Questions to Guide our Thinking

Layout Topics

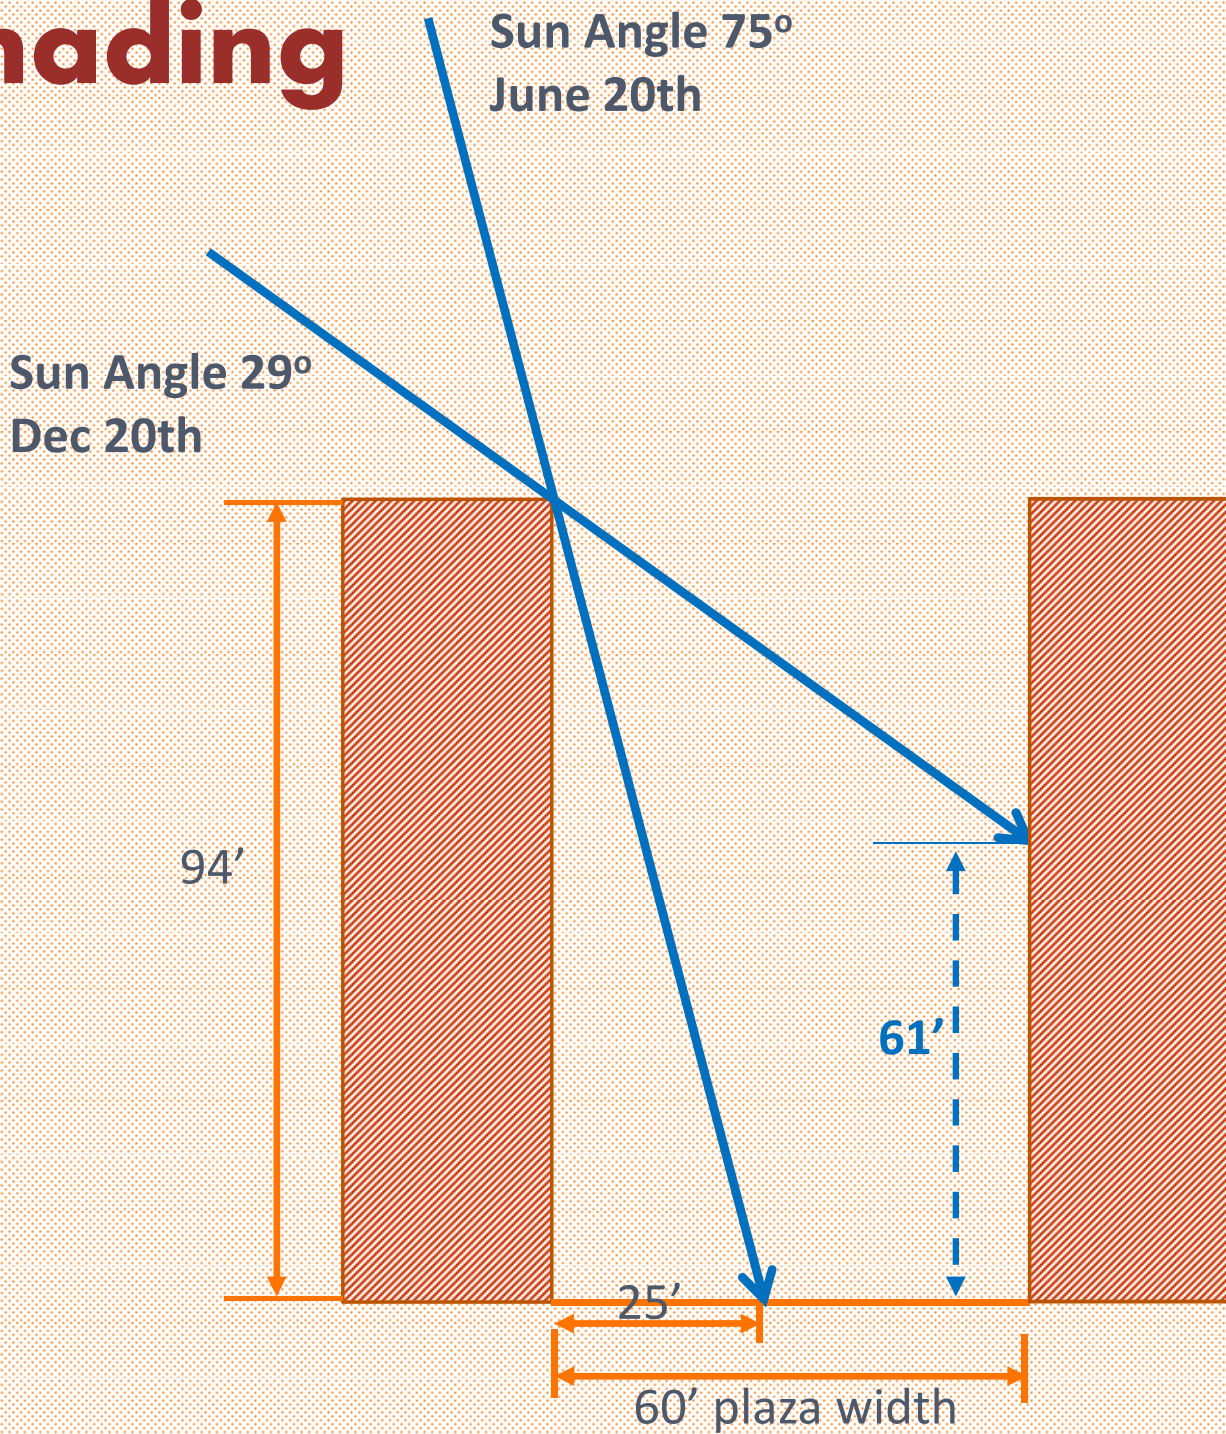
**Passageway
in perpetual
shadow from
Sept 15 to Apr 1
(Sun $\nless 57^\circ$)**

**In summer ~40%
always in shade**

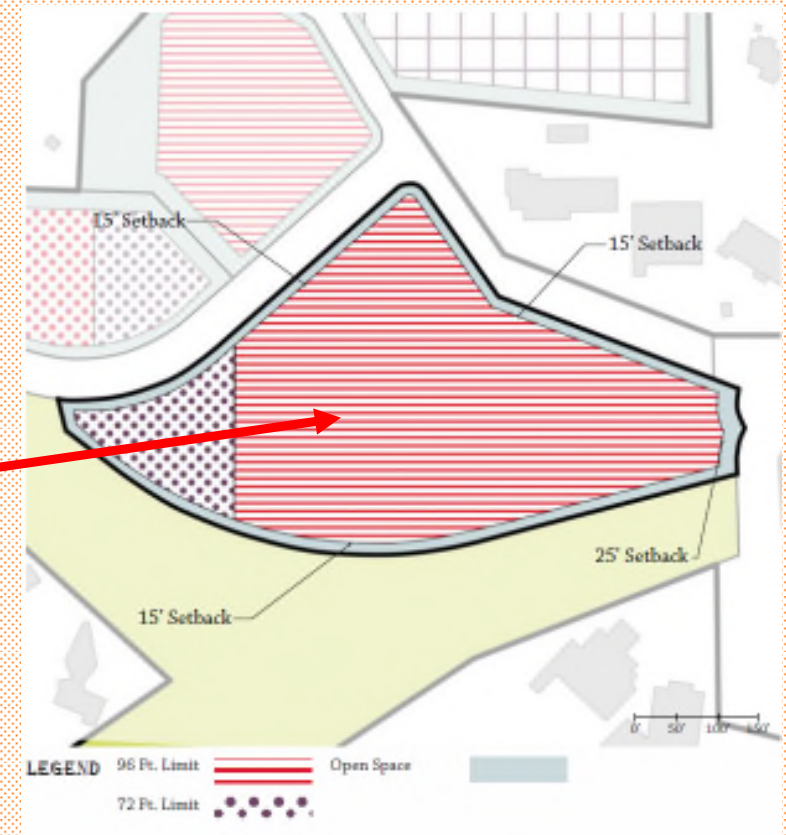
VC-N has a mostly N-S orientation (except for Buildings 14 A&B whose N sides will be in perpetual shadow) but at 96' from ground level (Buildings 13), they are actually taller above pedestrian level than VC-C buildings. They must abide by separation and stepback provisions, if approved.

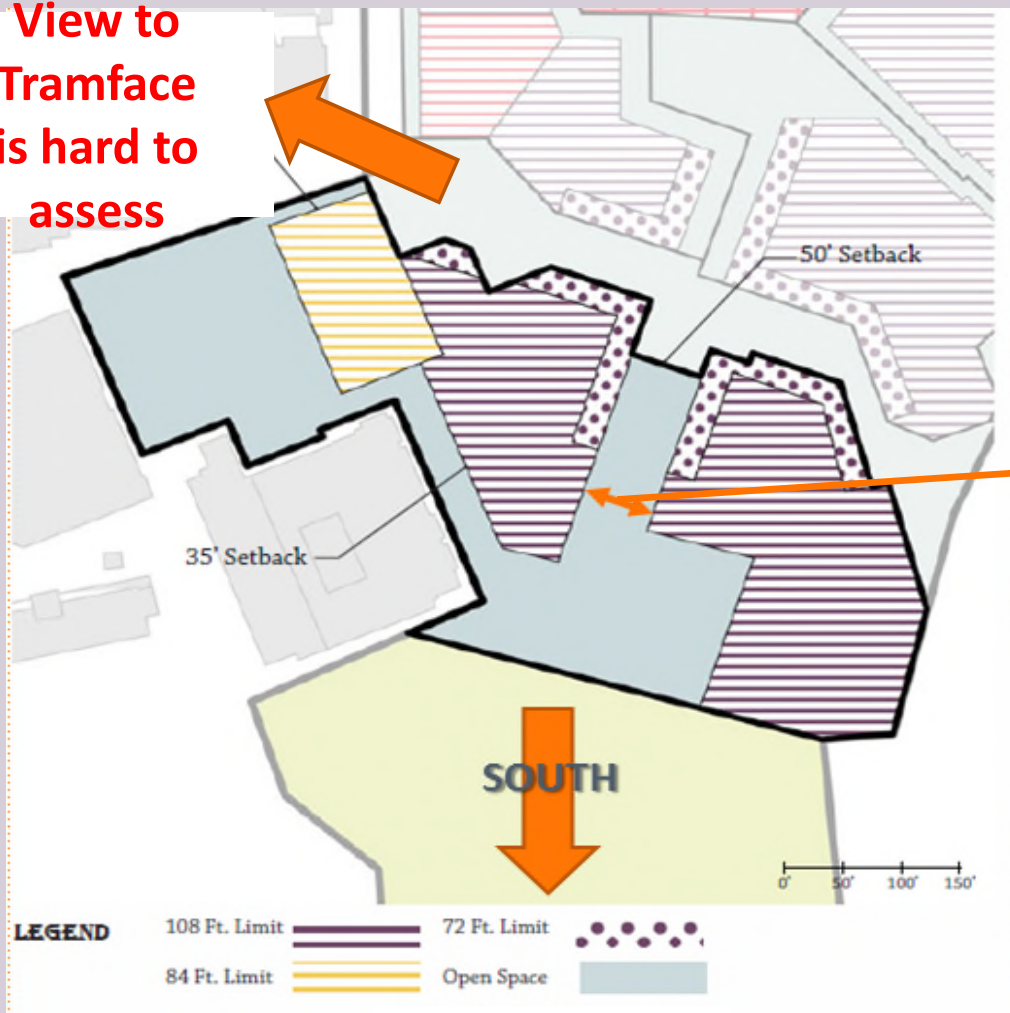
The principal building orientation is E-W, rather than N-S.

The principal views are to the West and to the South. In Lot 1, the main view lot, 108' buildings block the South view except for a corridor that is ~50-60' wide at its widest.

To the west, the only view corridor is along a narrow passageway.

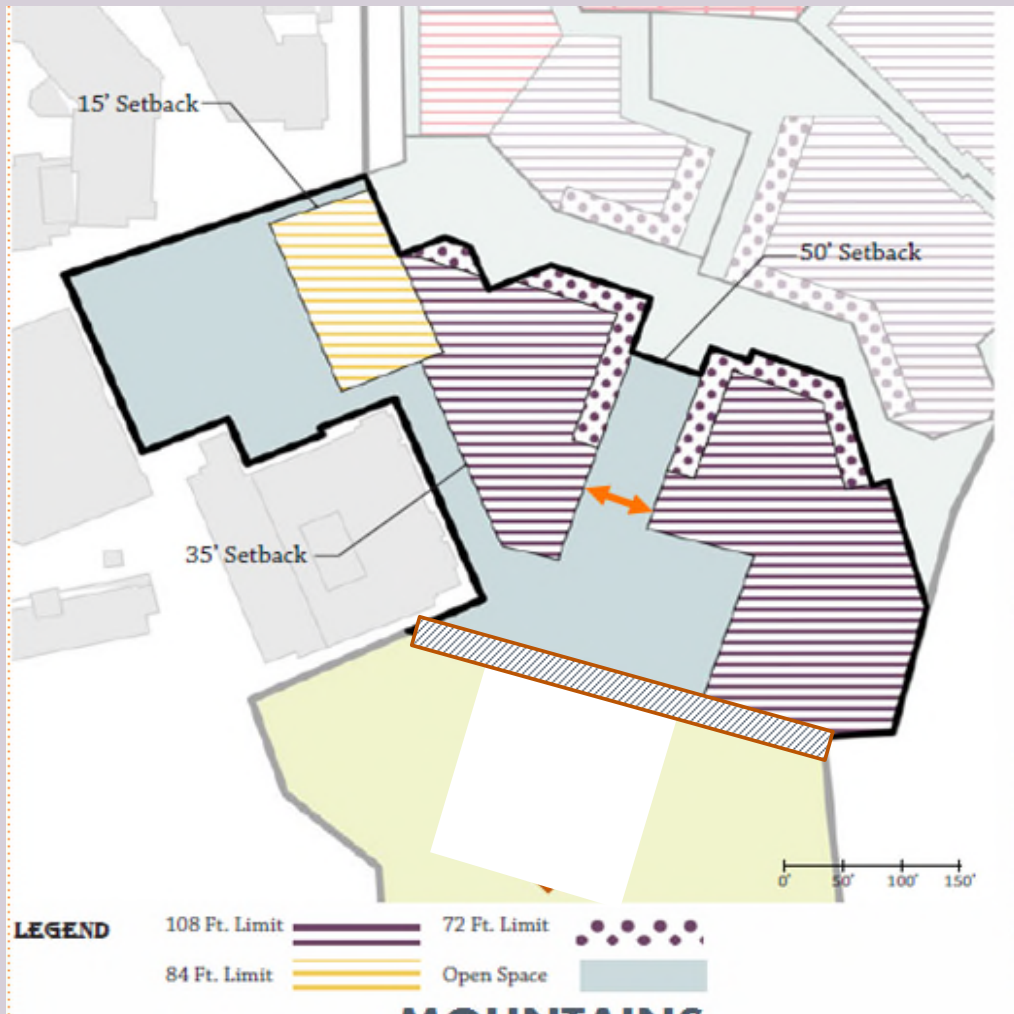
View to
Tramface
is hard to
assess

108' buildings
block the
mountain view
except for a
~50-60' wide
corridor

In addition the view of tram face over the current Village from the Parking lot will most likely be lost

Example with outwardly-oriented ski-base joint.

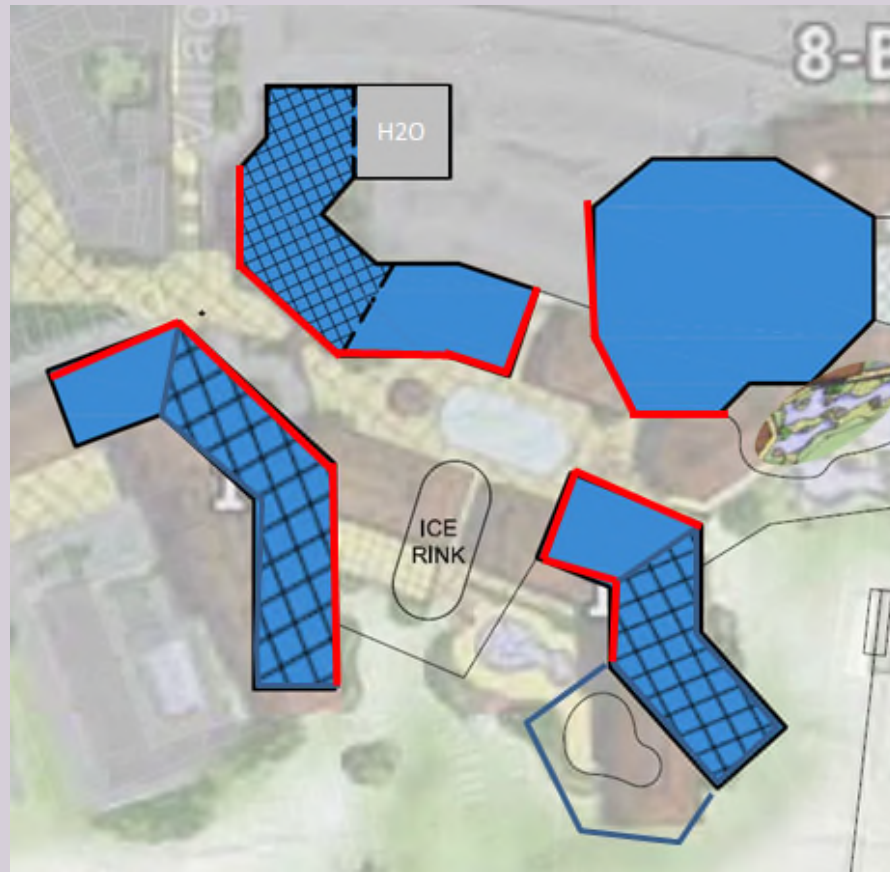
This design also creates what is called an “inwardly oriented” ski-base joint *. The Village is mostly walled off from the ski slopes (eg Beaver Creek, Aspen Highlands) – few visual clues of a village from ski slopes, few clues to draw skiers into retail core.
